PRE-BID ADDENDUM NO. 1

April 24, 2015

SURRY COUNTY GRAY'S CREEK MARINA RESTAURANT RENOVATIONS/ADDITIONS

IFB Project No. BC 2015-04

BUILDING TYPE:
MB
 SHEET NUMBER:
A101

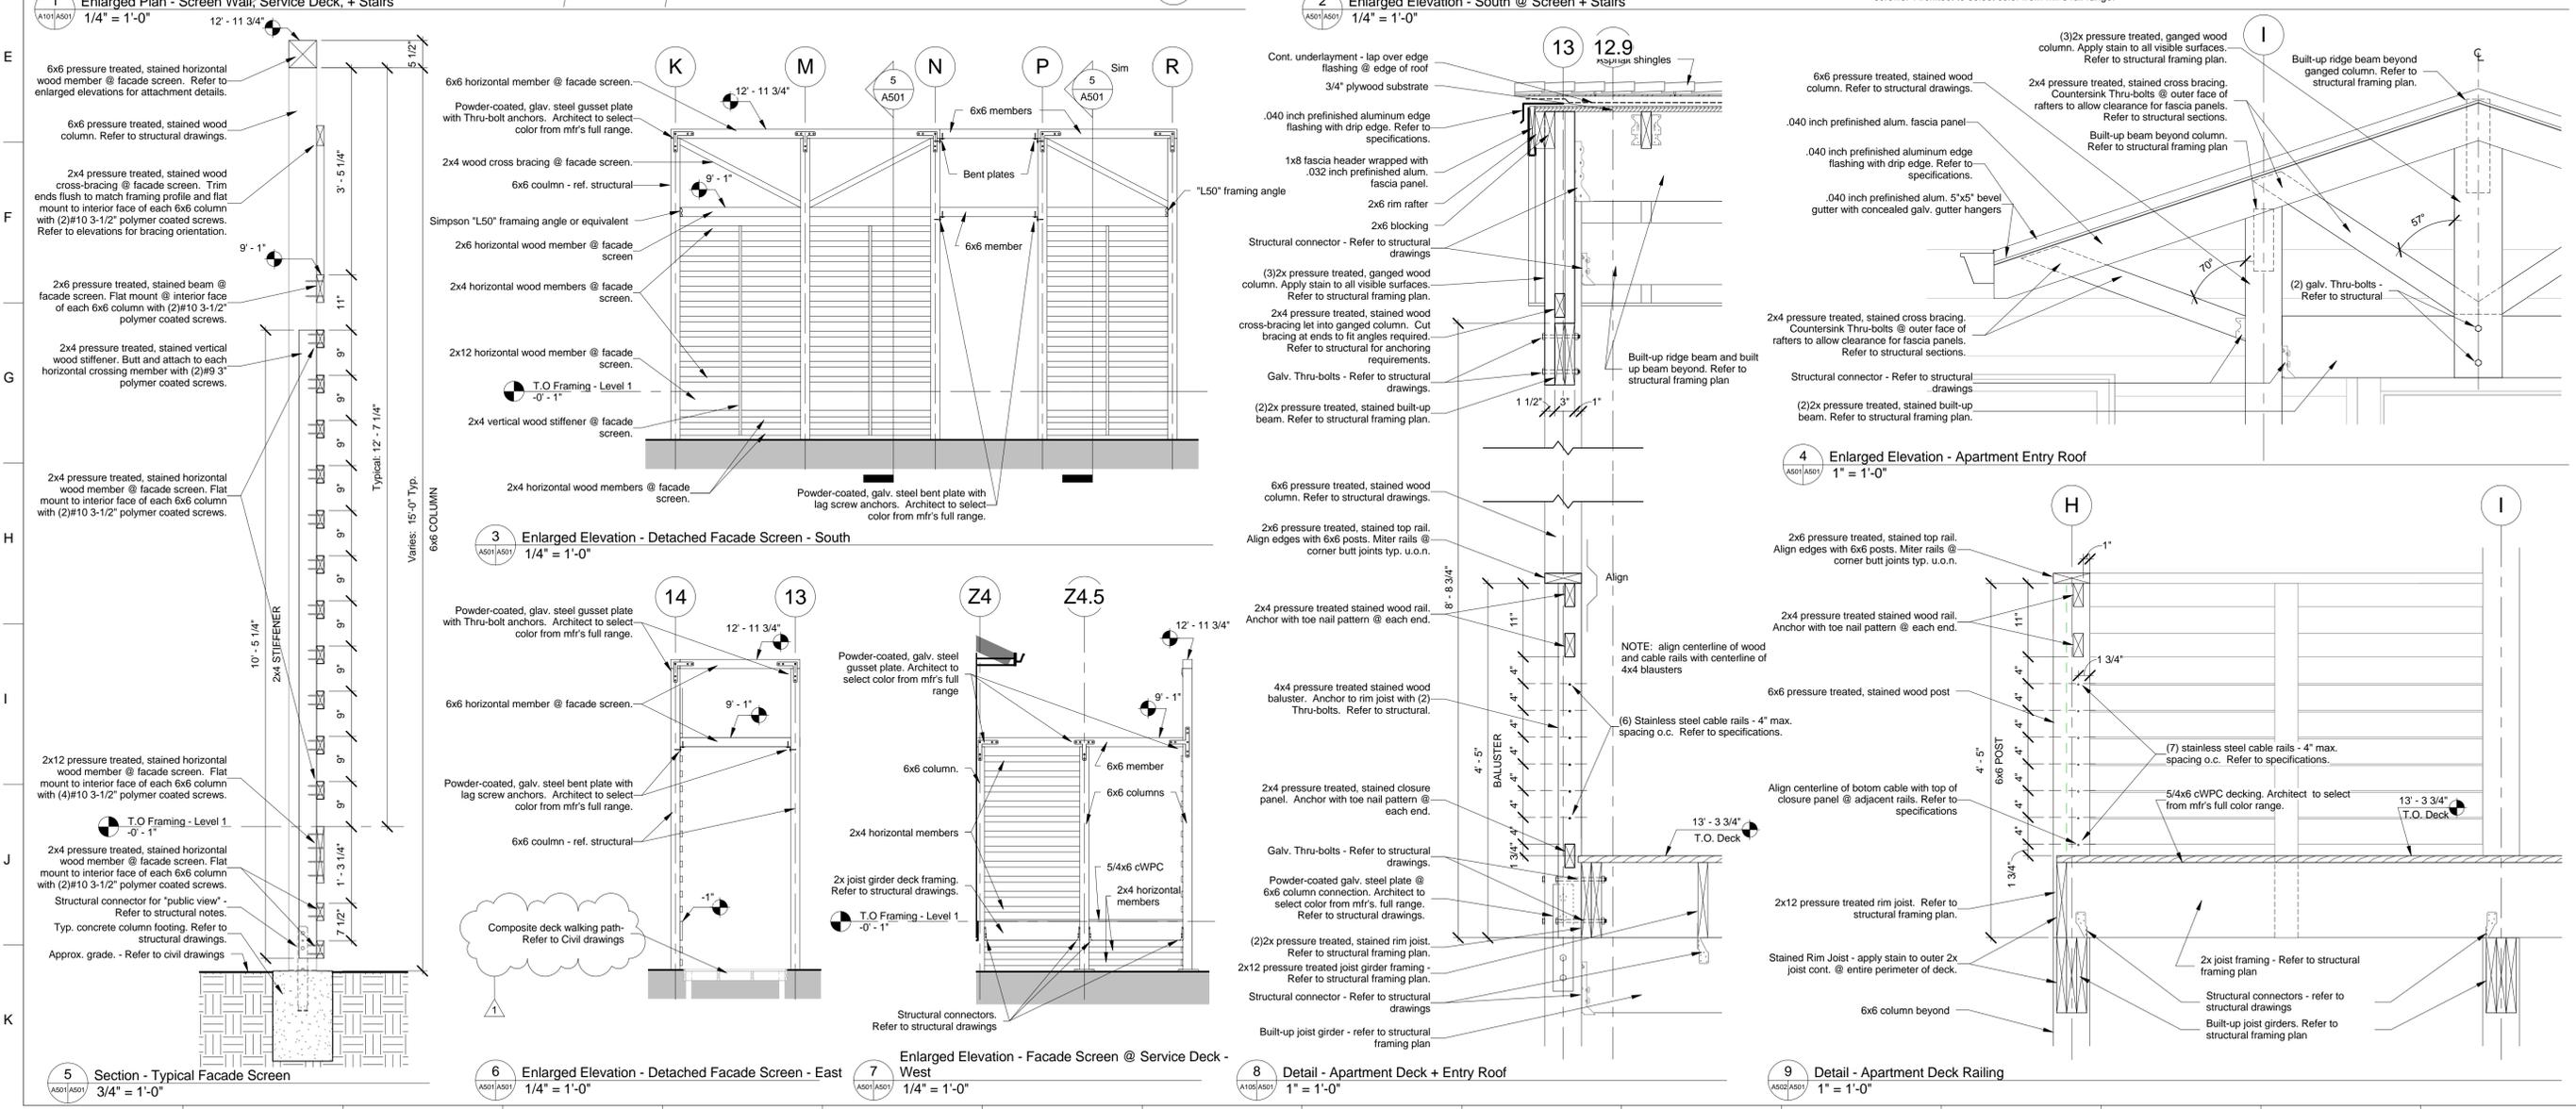
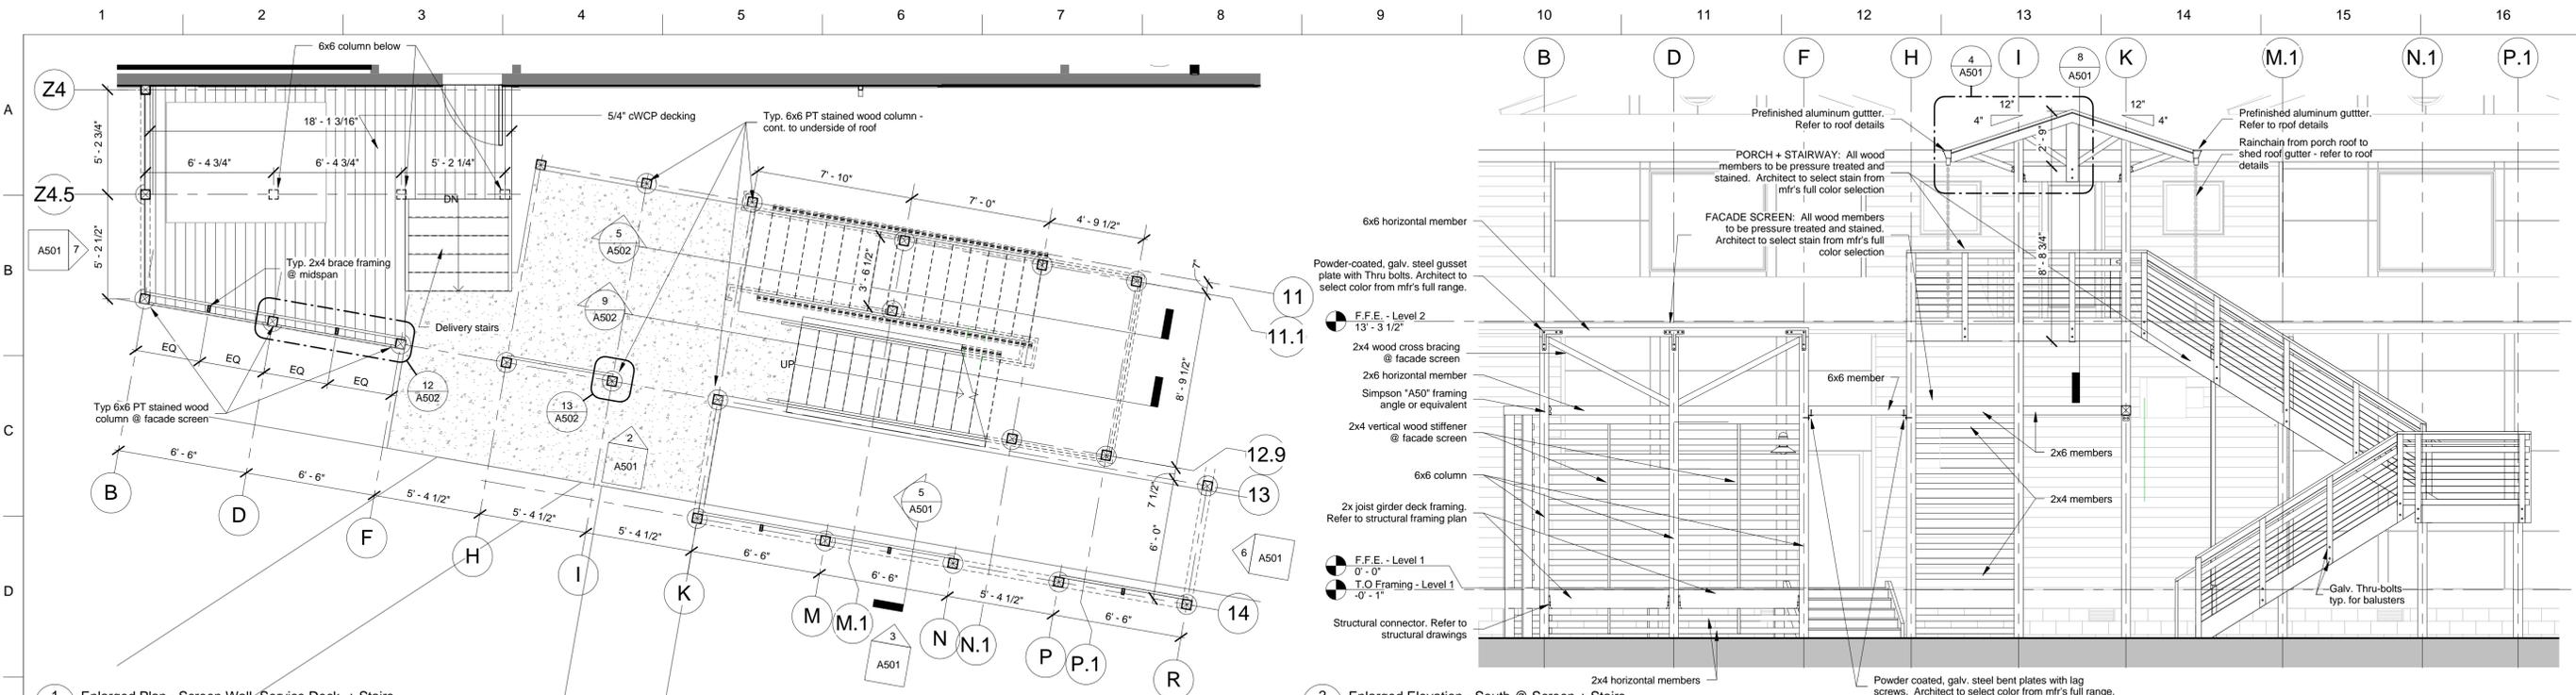
1. Sheet A101: Note #79 and 80 say Concrete slab, and composite Deck “By others, Refer to Civil Drawings” The civil drawings don’t show either of these as work by others. It also doesn’t show any details about the composite deck. Can you clarify what our responsibility is on the civil drawings?

ITEM #1 – A101 – NEW WORK – FLOOR PLAN – LEVEL 1

- The following changes are part of the project scope:
 - Revised Notes #79 + #80 to remove 'By Others'.

- **RESPONSE: Note #79 and 80 are to have the text “By others” removed. Contractor is responsible for the ‘Composite decking sidewalks’ as shown on civil drawings between concrete stair landing pads on the south side of the building. Composite deck detail is shown on CS500.**

KEY PLAN:
 SHEET TITLE:
 Marina Building - Exterior Details - Screen Walk, Service Deck, + Apartment Stairs
 BUILDING TYPE:
 MB
 SHEET NUMBER:
 A501

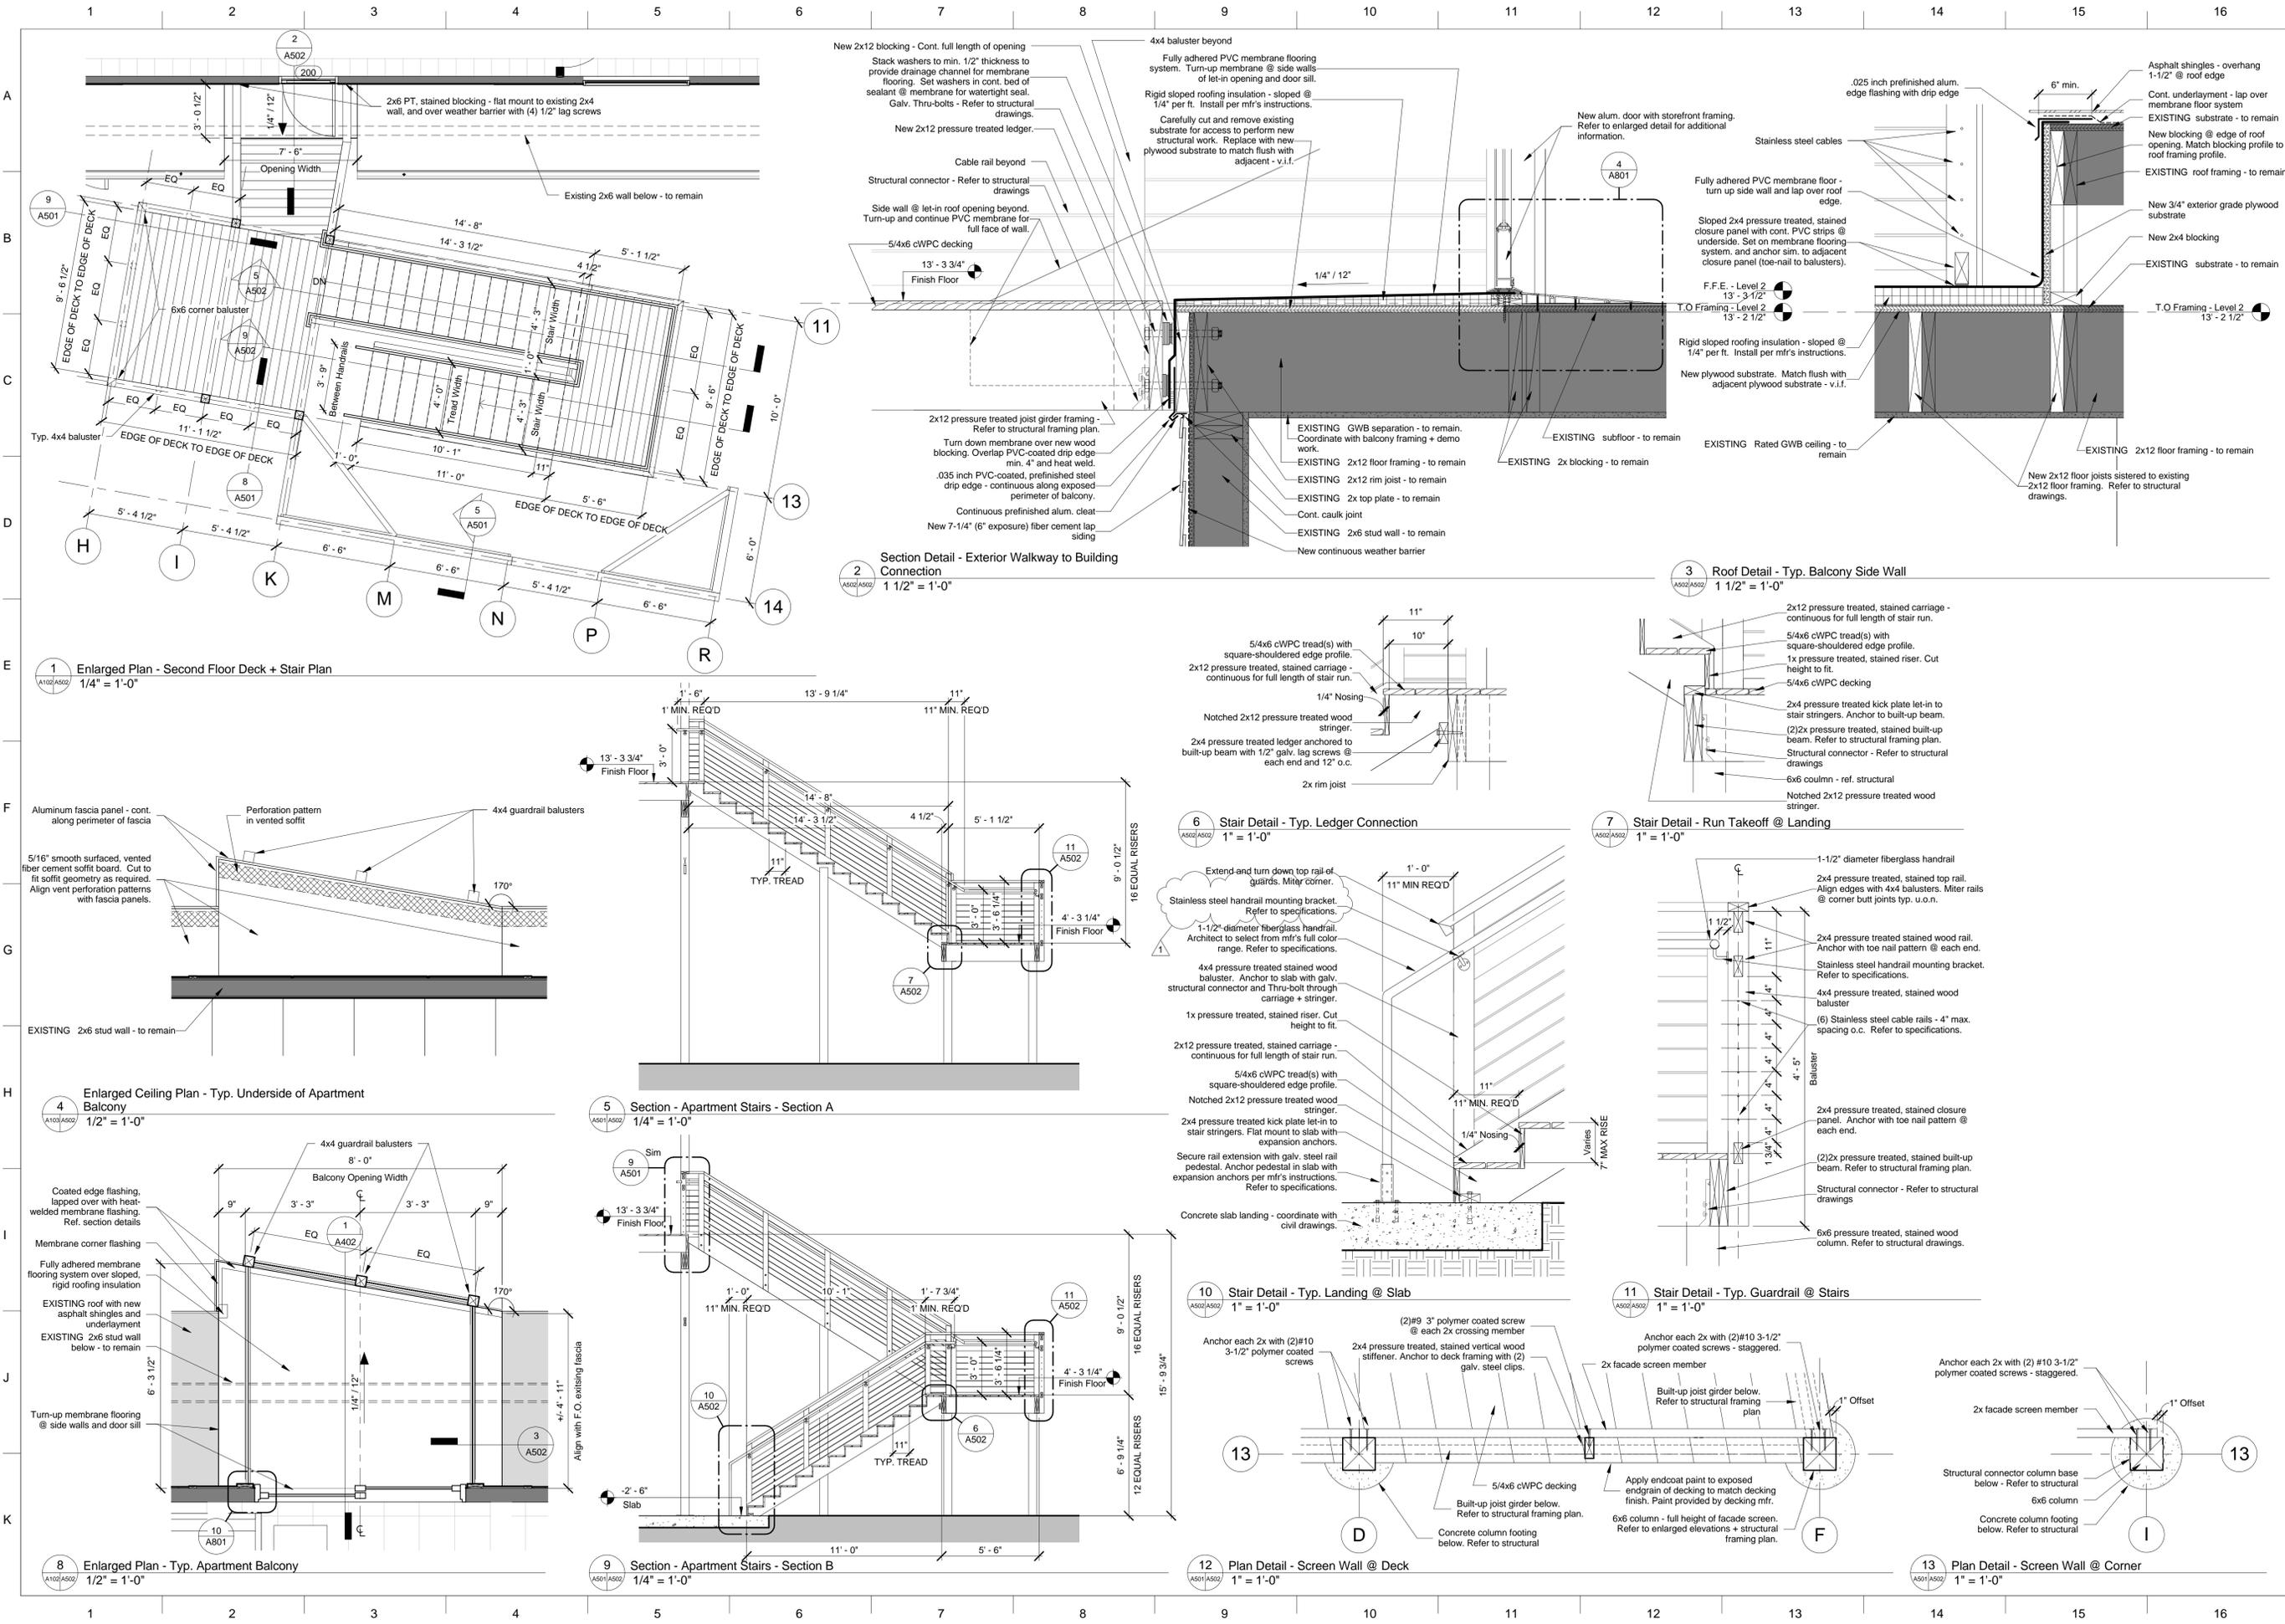
ITEM #2 – A501 – EXTERIOR DETAILS – SCREEN WALL, SERVICE DECK, + UNIT STAIRS

- The following changes are part of the project scope:
 - Detail 6 – Removed 'By Others' in reference to composite deck walkway.
